Countries:	CANADA, UNITED STATES	Document ID:	IK1600178
Availability:	ISIS, FleetISIS, Body Builder	Revision:	0
Major System:	CAB / SLEEPER / HOOD	Created:	3/5/2013
Current Language:	English	Last Modified:	5/29/2013
Other Languages:	NONE	Author:	Patrick Gotschall
Viewed:	71

Title: TerraStar Torsion Bar Retention Cotter Pin Design Change

Applies To: TerraStar built before 1/31/2013

Figure 1

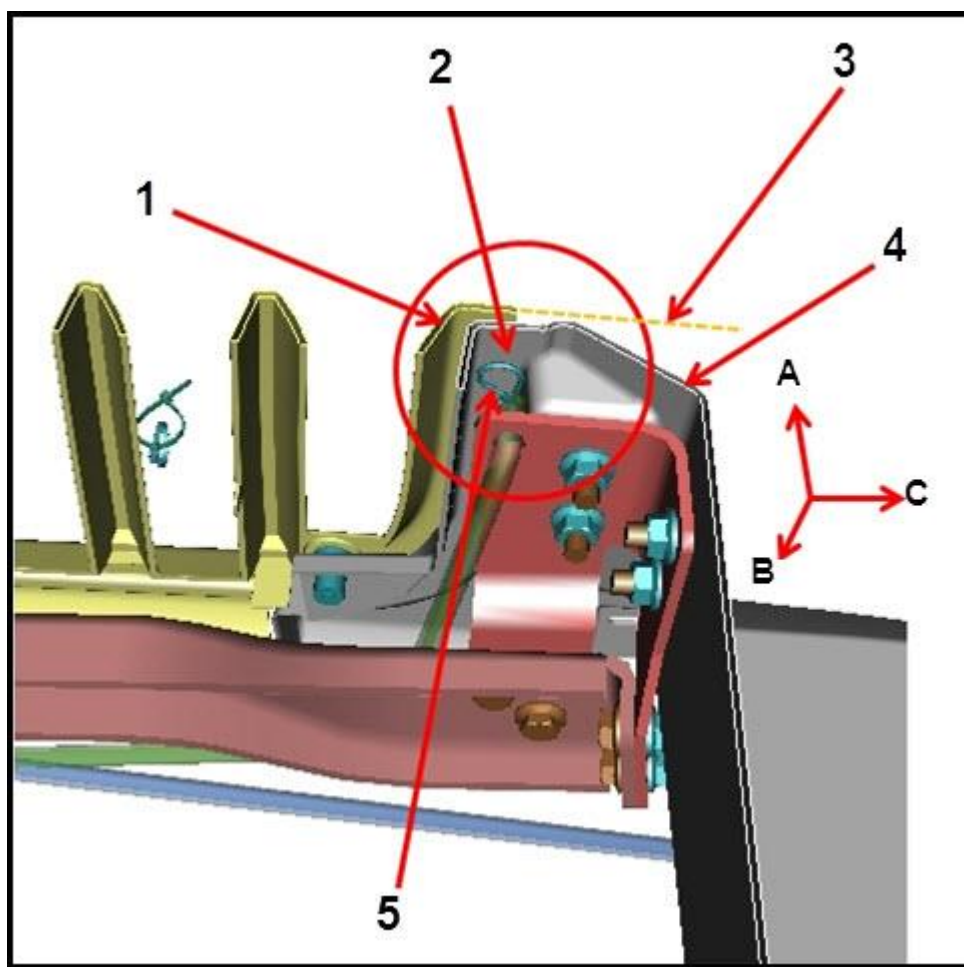
There has been a design change to the TerraStar torsion bar retention pin due to the possibility of the pin rotating and then wearing against and/or cracking the Grille Opening Reinforcement (GOR). This is a cosmetic issue that is normally hidden by the grille and the headlamp, however it may be discovered if these parts are removed for service.

1. Overview of area affected (section through grille/hood looking forward and down) (*Figure 1*):

A replacement cotter pin with a smaller loop has been put into production as of 1/31/2013. Should it be desired, the cotter pin on the trucks built prior to this date may be swapped with P/N 6102322C1 (the old part number was 3531907C2).

Figure 5

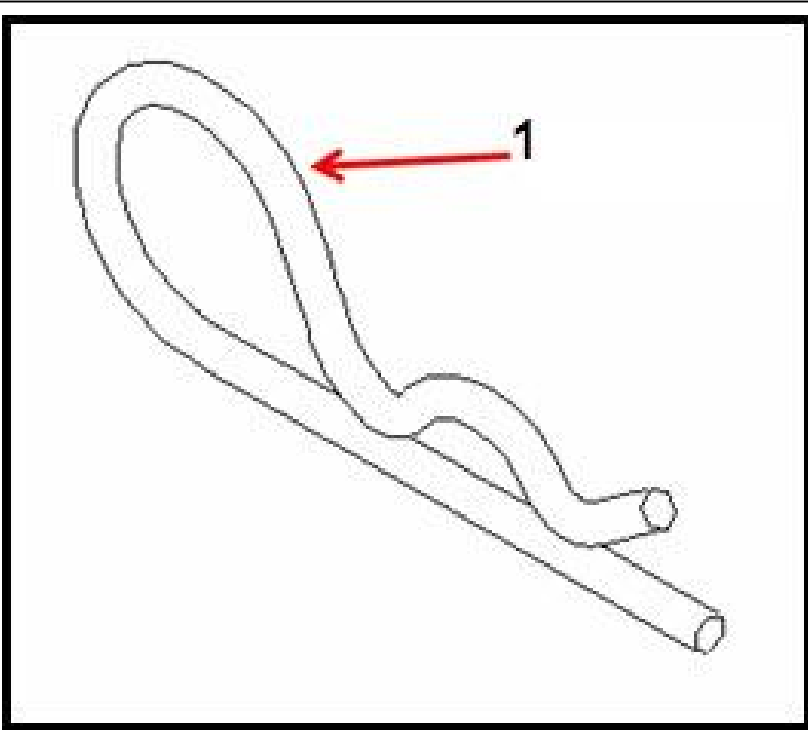
5. Differences between old and new cotter pin (*Figure 5*).

1. Loop reduced from 5/8" to 3/8"
